BAR Meeting
July 20, 2016

ISSUE: Partial Demolition/Capsulation and Certificate of Appropriateness for Addition and Alterations

LOCATION: 308 Commerce Street

BAR2016-00204 & 2016-00206

Figure 2. CURRENT SUBMISSION, east (side) elevation.

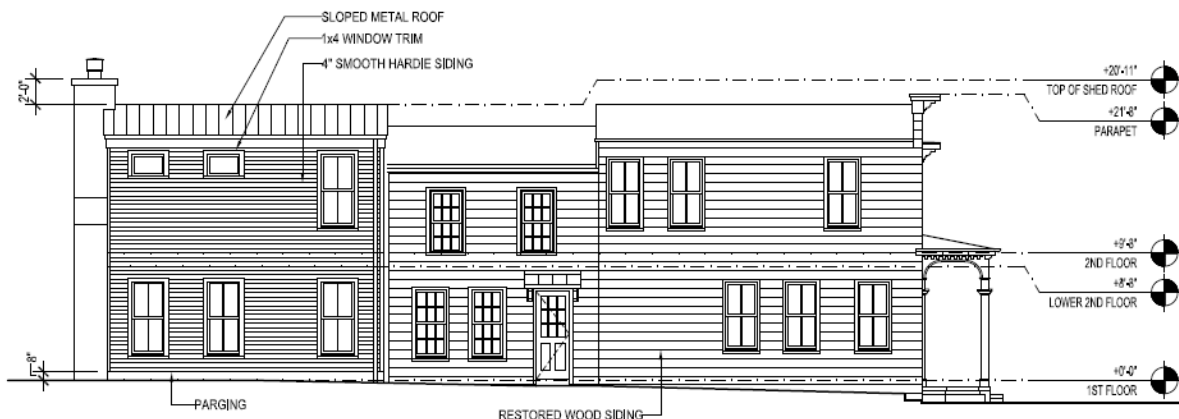
This version, the current submission, utilizes a simple shed roof form in line with the height of the main block. As in the previous study, the fenestration was revised to include aligned single windows with a 2/2 light configuration, a reduced parged concrete foundation height and a more

refined and visually lighter chimney. Staff strongly supports the current application finding it to be consistent with the *Design Guidelines* and to satisfy the concerns previously raised by the BAR. The addition is differentiated from the existing house yet appropriate for the context and complementary to the existing building. As a reminder, the east (side) elevation will only be obliquely visible through the yard and the rear (south) elevation will not be visible. The north elevation will be visible, and the use of the shed roof and 2/2 windows here make the new construction coexist harmoniously with the historic building from the street. The use of high-quality composite materials such as fiber cement siding and composite trim will further differentiate the new from the old.

EXISTING FRONT / NORTH ELEVATION

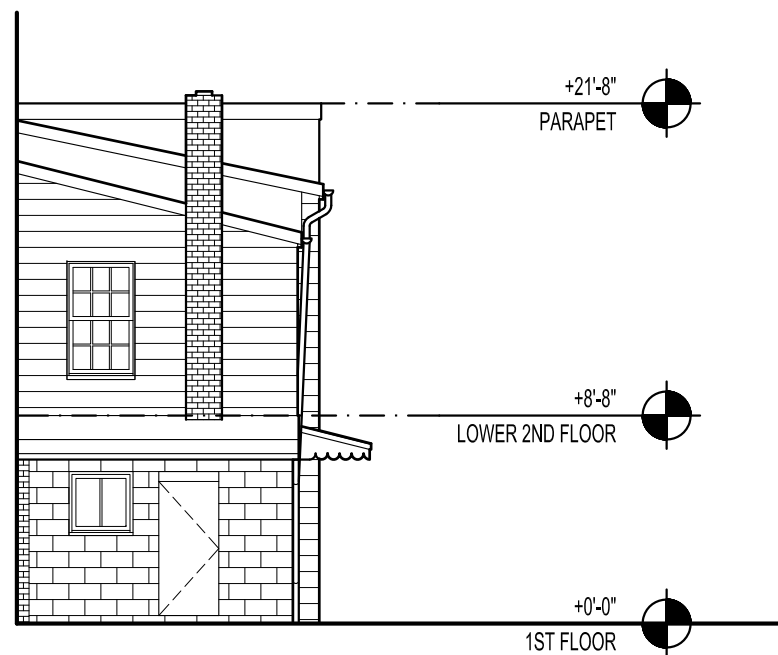
AFTER EXISTING METAL SIDING HAS BEEN REMOVED, OWNER WILL WORK WITH BAR STAFF ON THE DESIGN OF THE CORNICE DETAILS, WINDOW TRIM BRACKETS, ETC.

1. The applicant must work closely in the field with BAR staff on the final design of the cornice, window and door trim of the original building while using documentary evidence in the field prior to submission of the building permit.
